# GRADING AND EROSION CONTROL PLANS FOR WALDEN SANITATION DISTRICT WASTEWATER TREATMENT PLANT PROJECT EL PASO COUNTY, COLORADO MARCH 2026

EPC DPW Stormwater did not fully review the last GEC submission since it was not associated with a stormwater permit. New information provided with this submission has triggered the requirement for an ESQCP, so full comments will be provided at this time. See comment on sheet 12 for additional information.

SHEET TITLE: OVERALL SITE PLAN		
PROJECT NUMBER: #3774	SCALE: 1"=60'	SHEET: C3

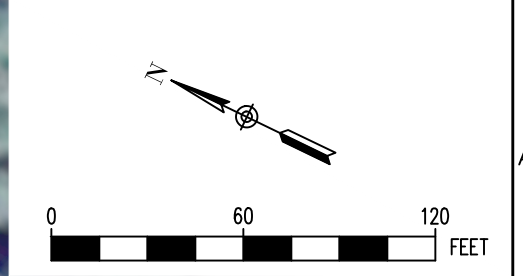
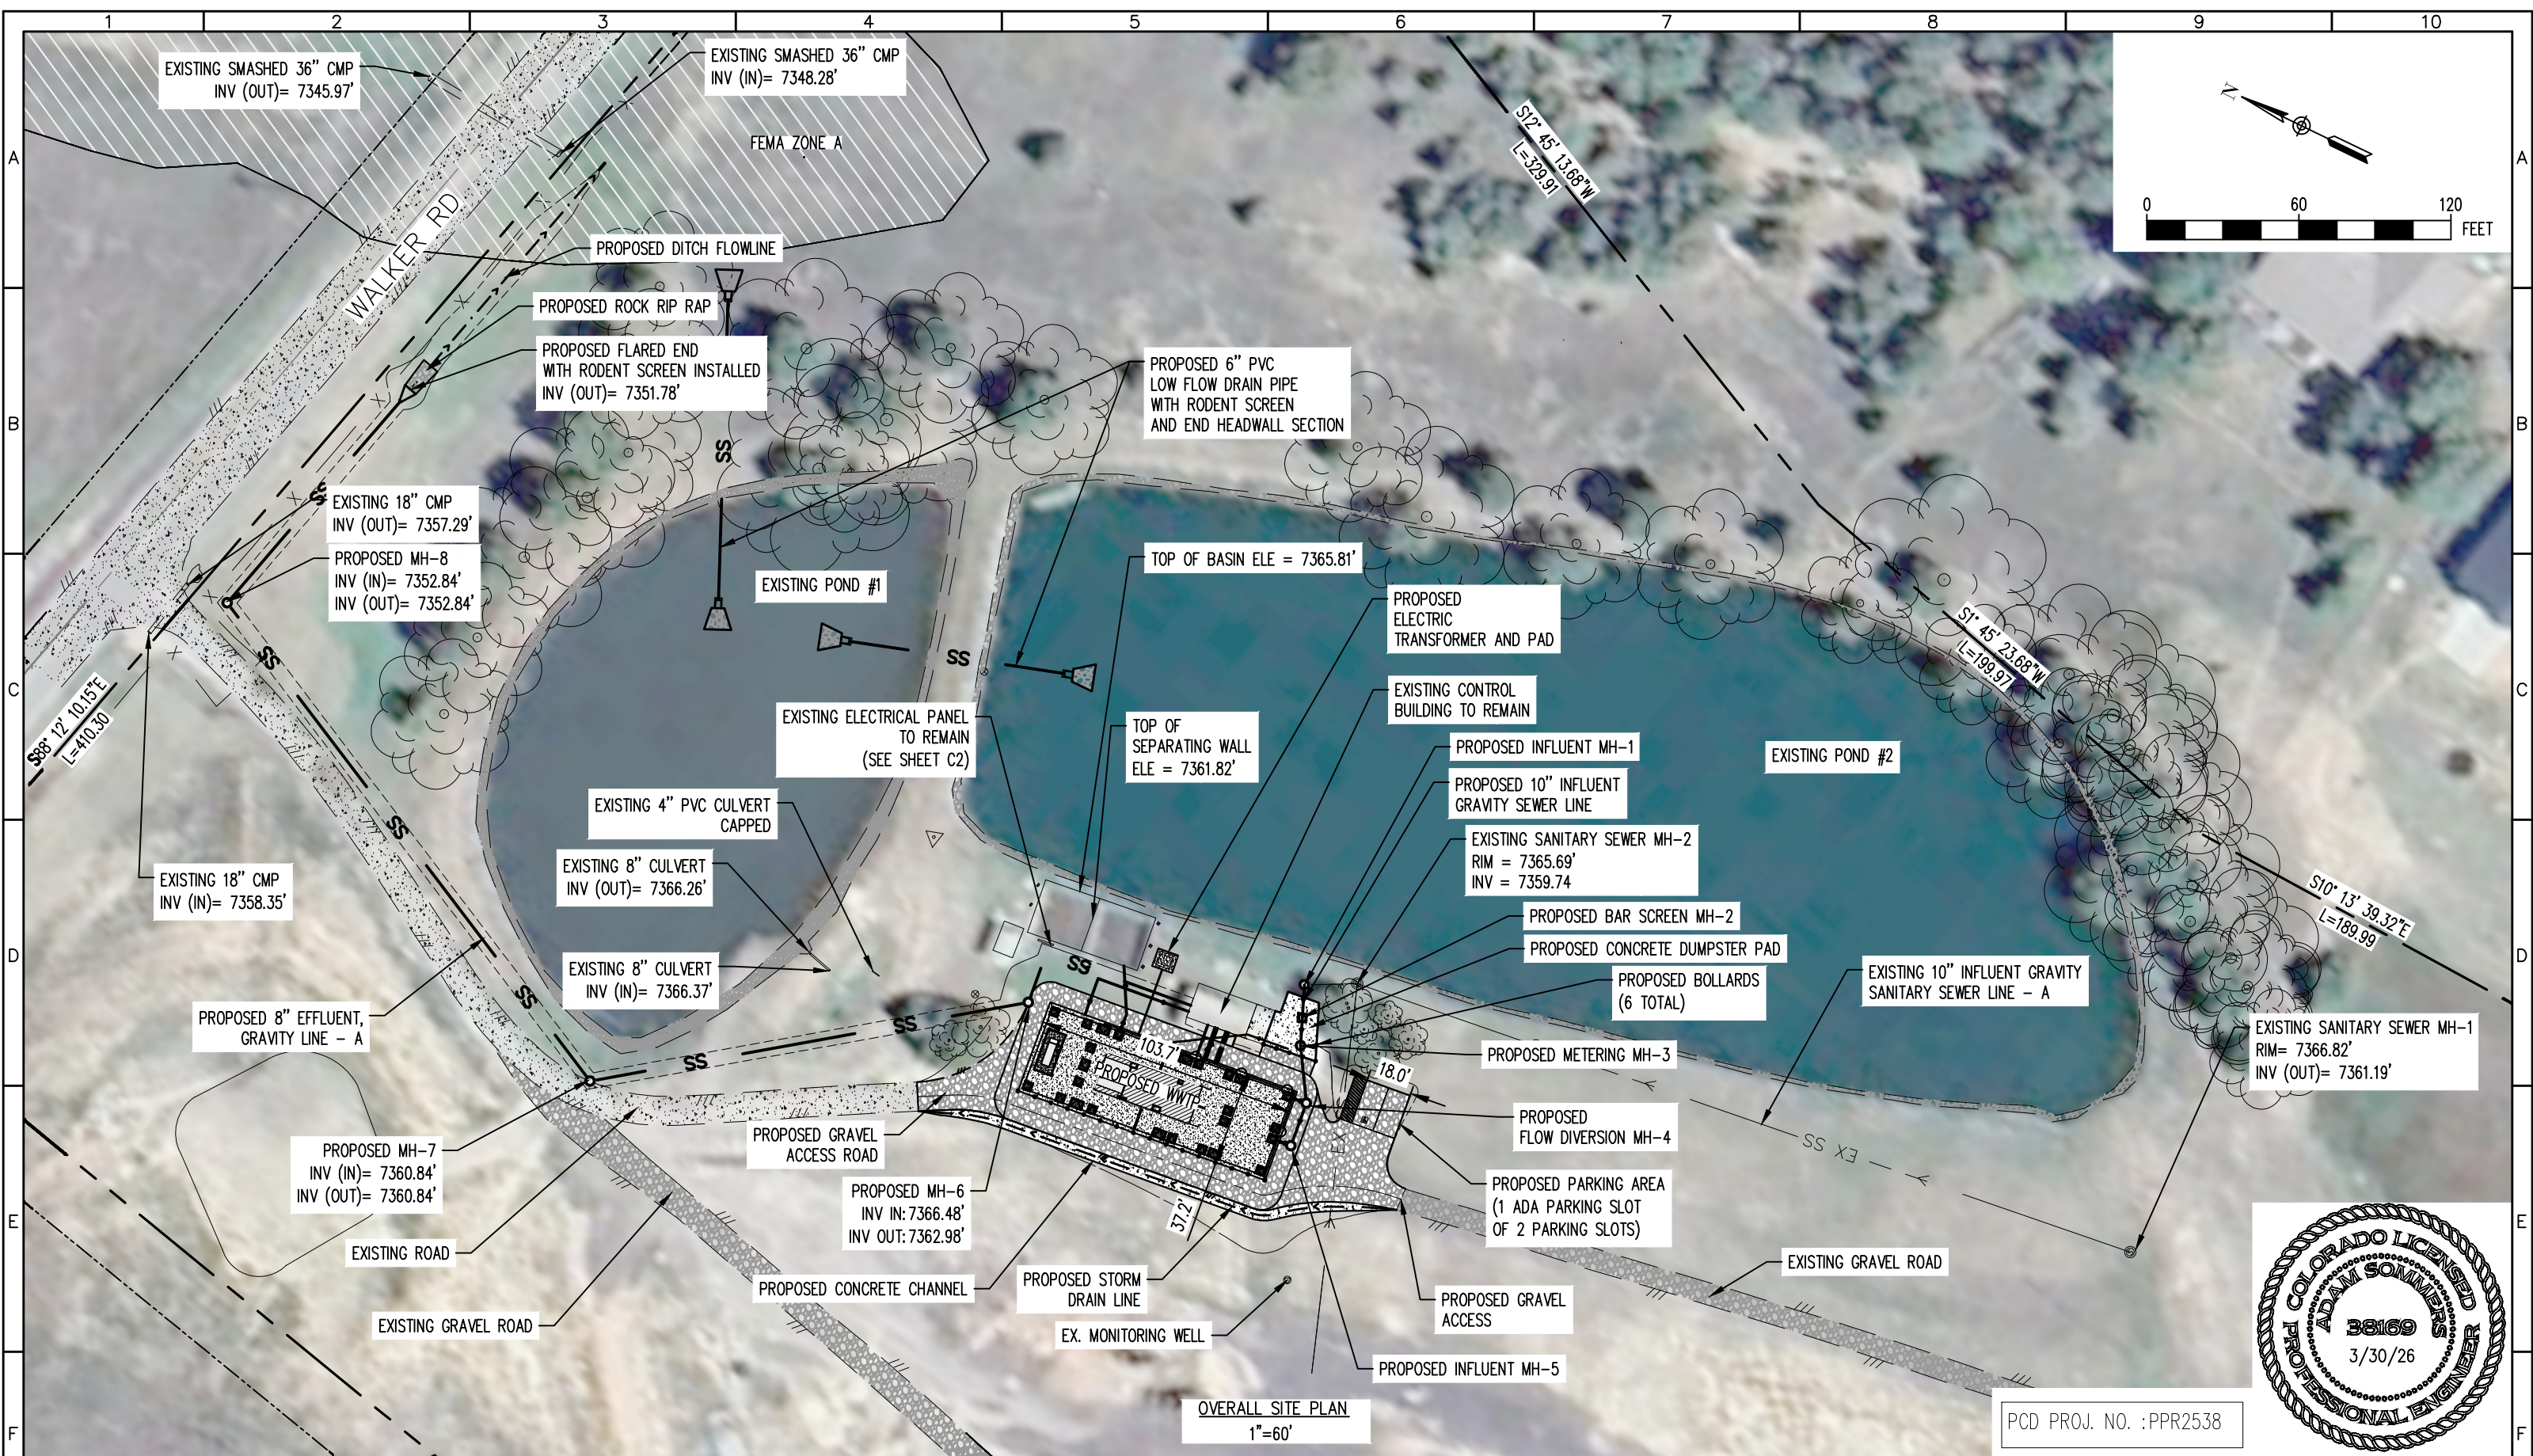
If "limits of disturbance" and "construction boundary" are the same, change to "limits of construction/disturbance" or otherwise show as separate line types for each on the legend and figure.

SHEET TITLE: EROSION CONTROL PLAN I		
PROJECT NUMBER: #3774	SCALE: 1:100	SHEET: C7.1

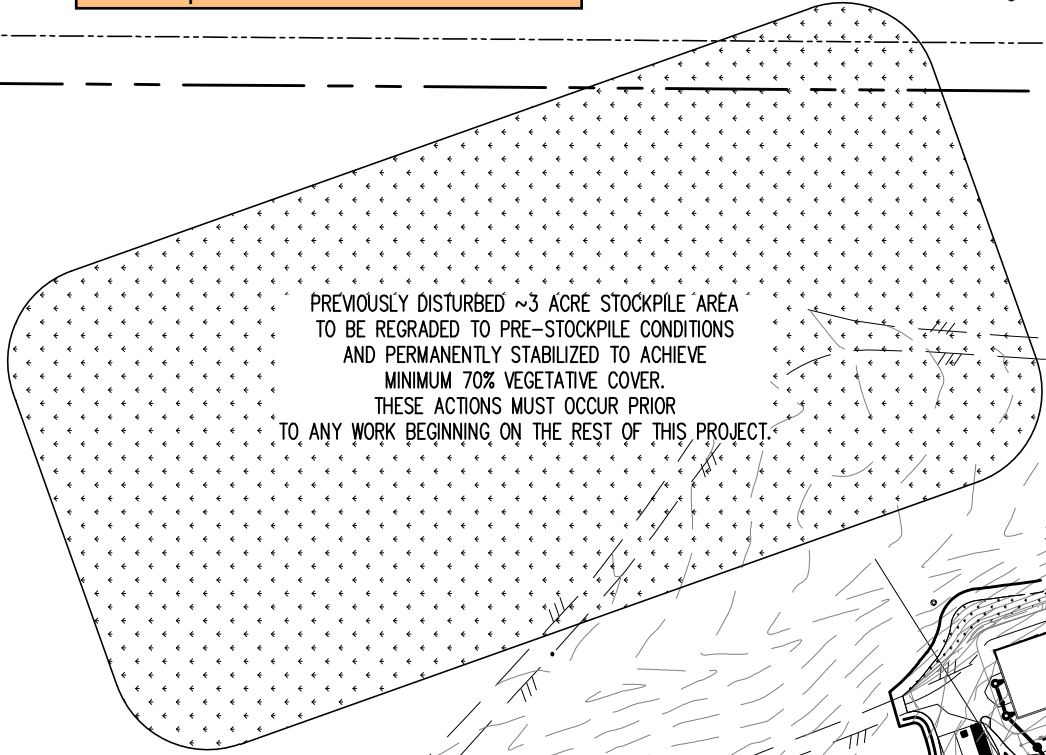
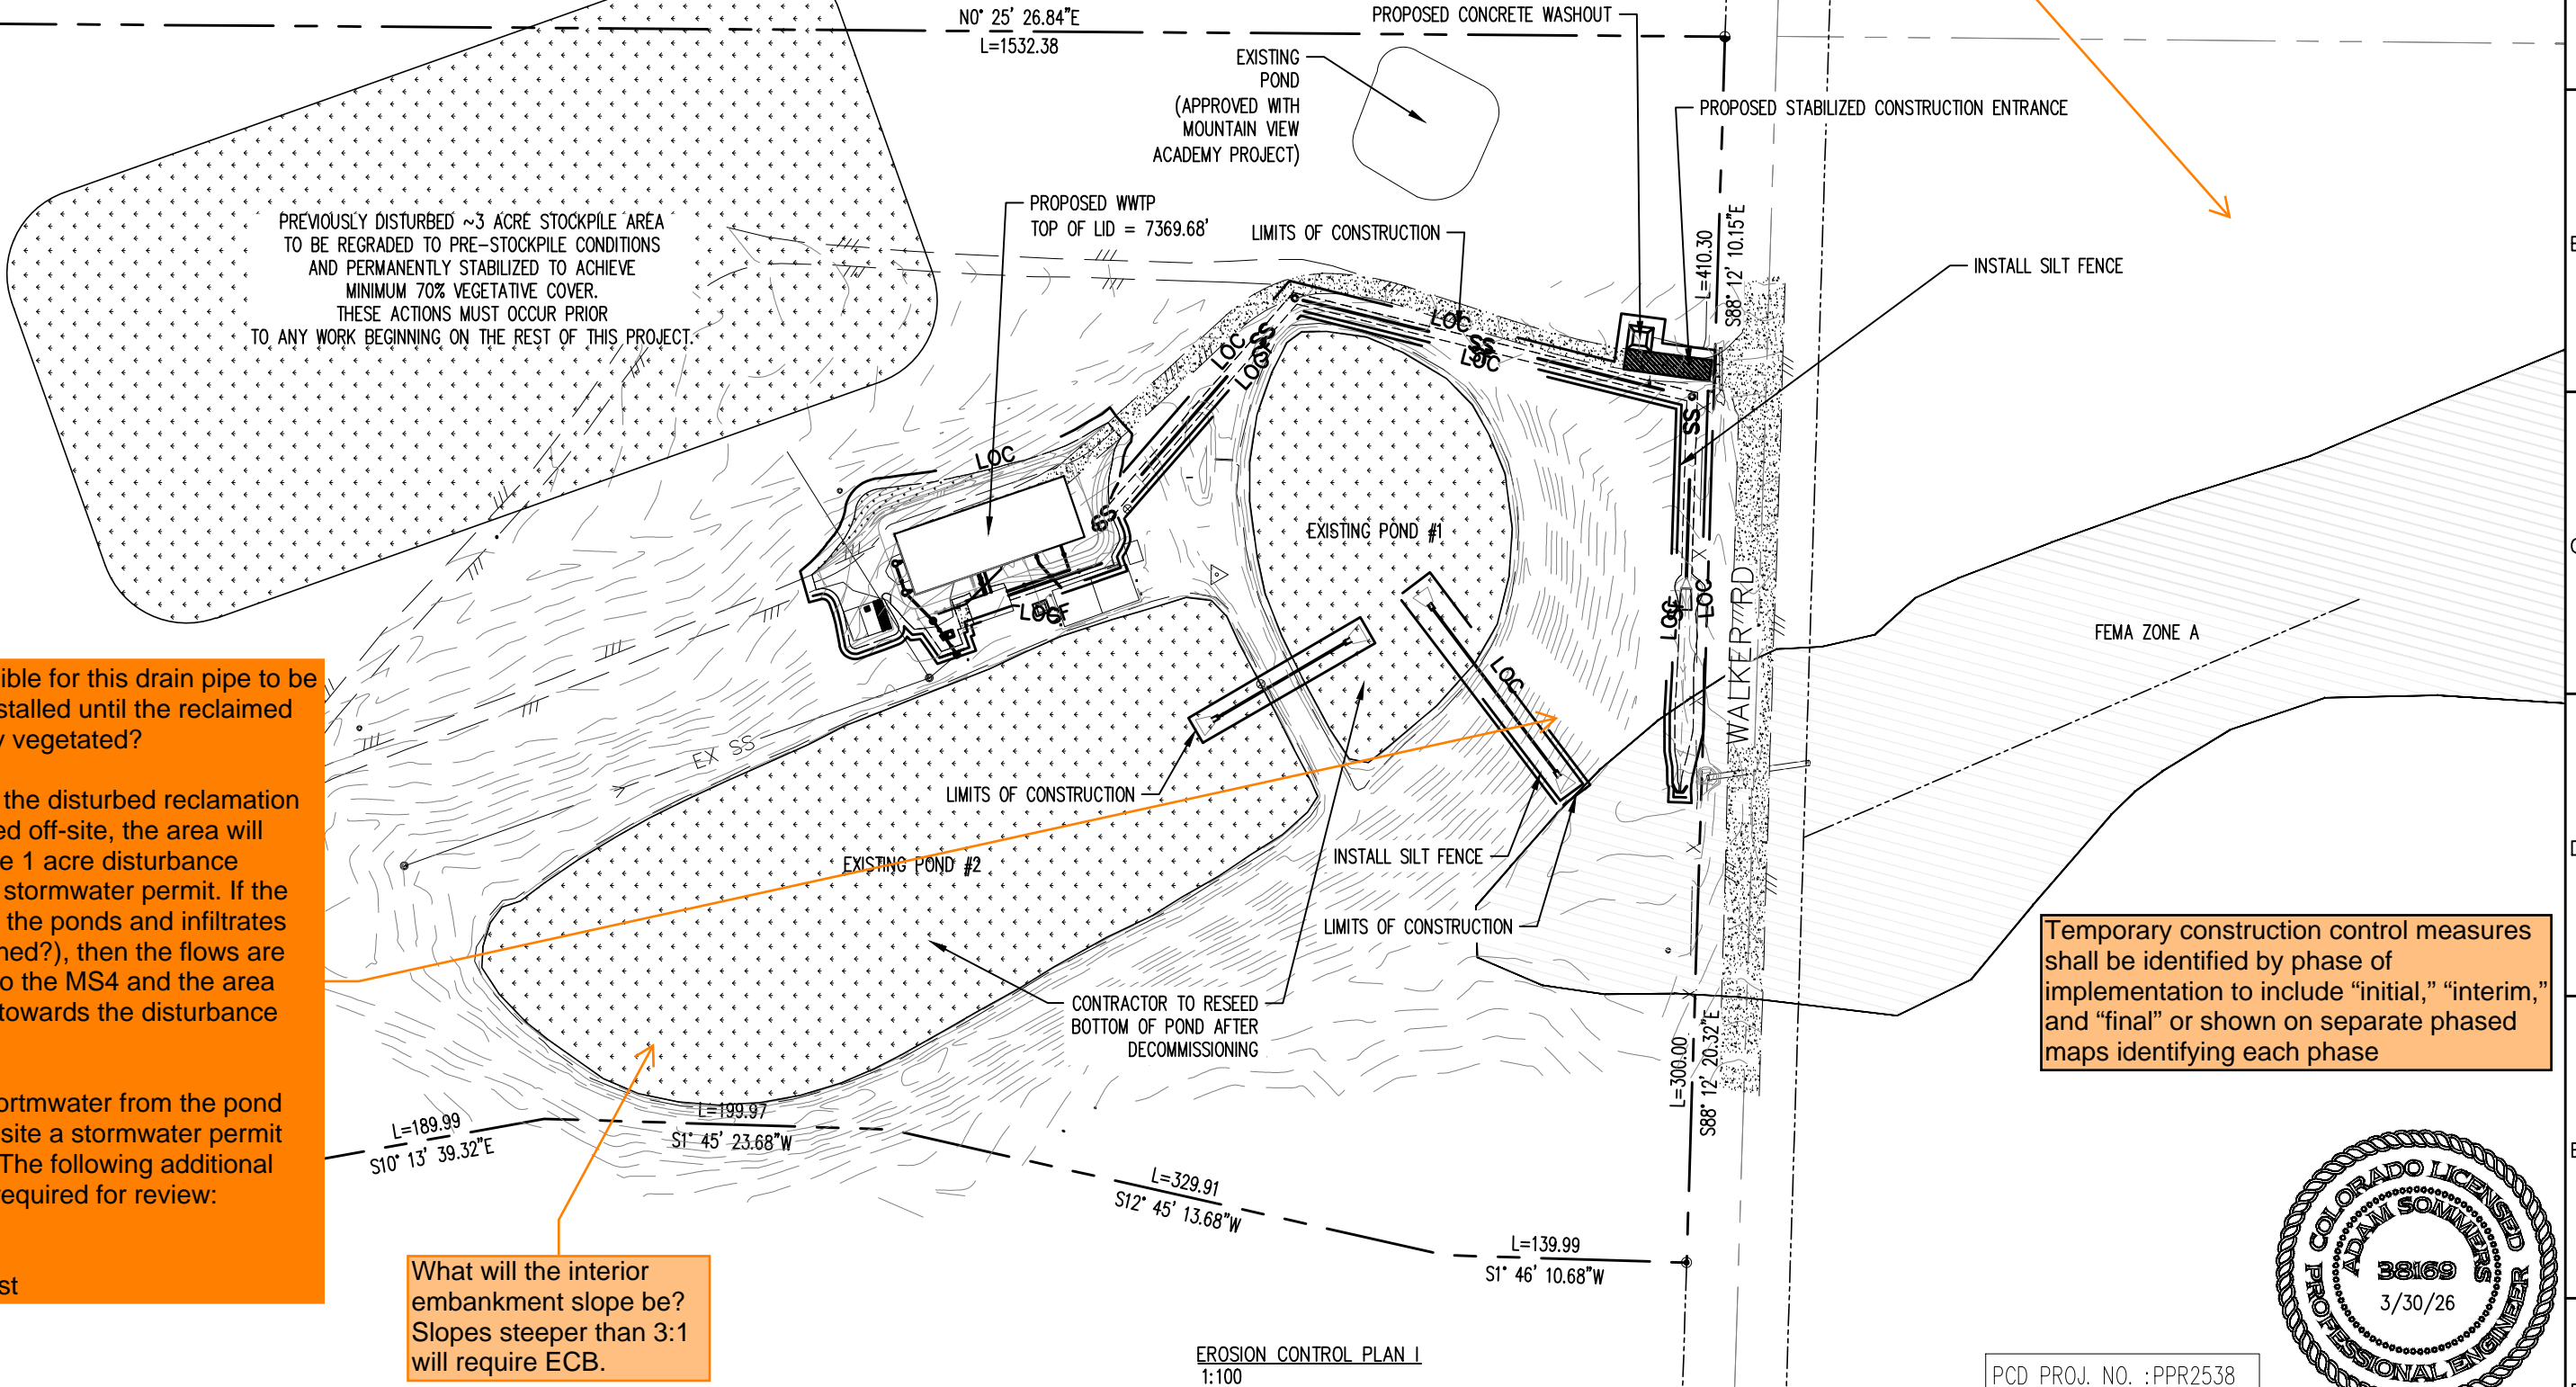
Will there be a staging/storage area for the pond dredging or pipe/equipment? If so, please show area on plans and include a detail

GEC Checklist items M & N. Please provide contour labels and flow arrows

GEC Checklist item C. Provide labels for adjacent property, include parcel numbers

Show areas of cut and fill.

Would it be possible for this drain pipe to be capped or not installed until the reclaimed pond area is fully vegetated?

Essentially, if stormwater from the pond area leaves the site a stormwater permit will be required. The following additional forms would be required for review:  
 - ESQCP Form  
 - SWMP  
 - SWMP Checklist

What will the interior embankment slope be? Slopes steeper than 3:1 will require ECB.

Temporary construction control measures shall be identified by phase of implementation to include "initial," "interim," and "final" or shown on separate phased maps identifying each phase
